RE: Tilbuster Solar Farm – SSD 9619 – Response to Submissions - Revised Biodiversity Development Assessment Report

Attachment 1: Detailed BCD Comments – Tilbuster Solar Farm (SSD – 9619) – Response to Submissions – Revised Biodiversity Development Assessment Report

Figure 1: Aerial photograph of development site and locality

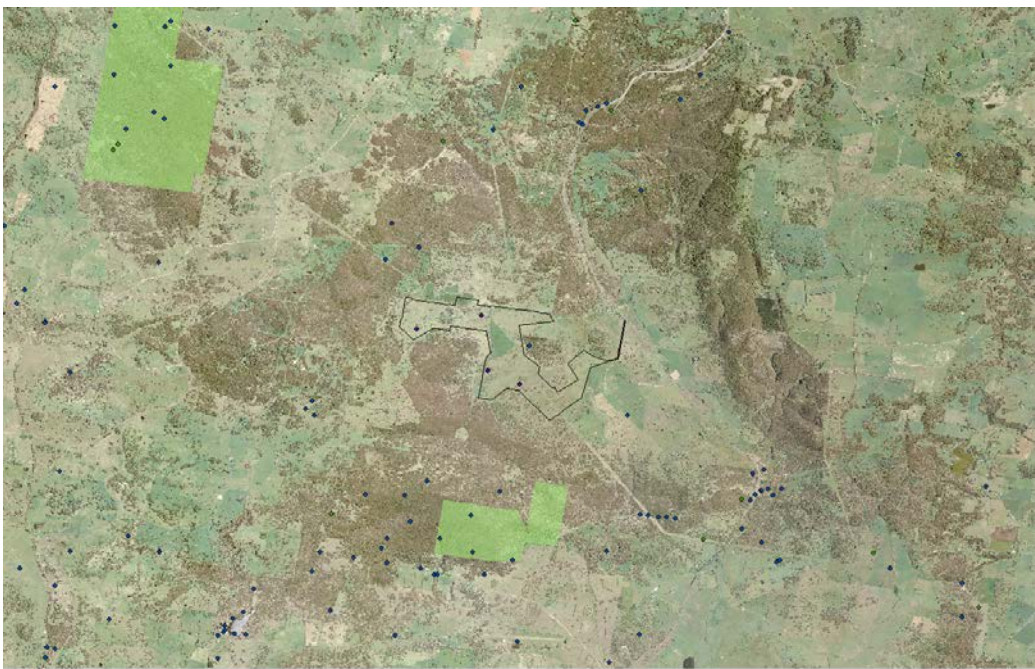
While the aerial photograph below, obtained from the Department's ArcGIS Image Catalogue, demonstrates the degraded nature of many parts of the site, it also demonstrates the overall poor condition of native vegetation across the broader landscape.

Figure 2: Location (red circle) of potential habitat linkage

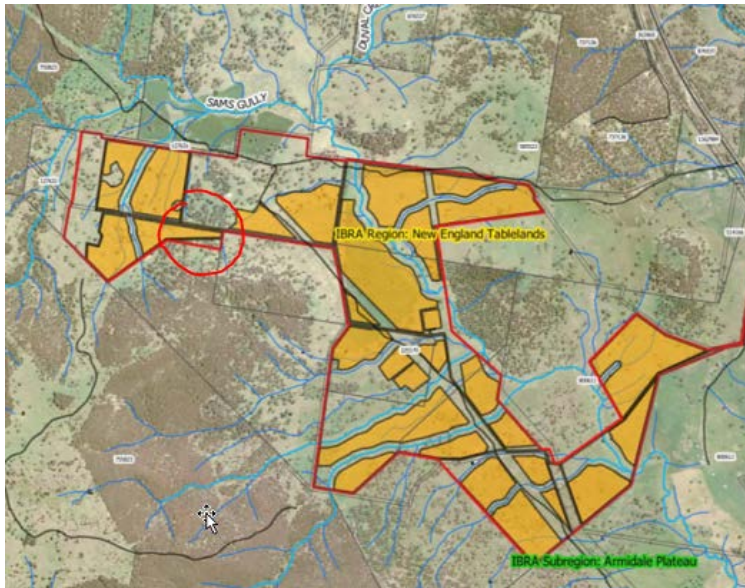
The BDAR also indicates that a small part of the development footprint will be located across what appears to be a north-south vegetated corridor (indicated by the red circle on the image below) which may be utilised by koalas, which are known to occur on site. Vegetation to the north of the footprint comprises the highest quality stand of grassy box gum woodland on the development site, which should be connected via habitat linkages to the south where other stand of native vegetation occur.

8. Further consideration should be given to avoiding impacts on high quality stands of the critically endangered ecological community White Box Yellow Box Blakely's Red Gum Woodland that have a vegetation integrity score of at least 33.
9. The development footprint should be revised to avoid the severing of connectivity at the location illustrated by the red circle in Figure 2 above.

9. The development footprint should be revised to avoid the severing of connectivity at the location illustrated by the red circle in Figure 2 of Attachment 1 to this letter.
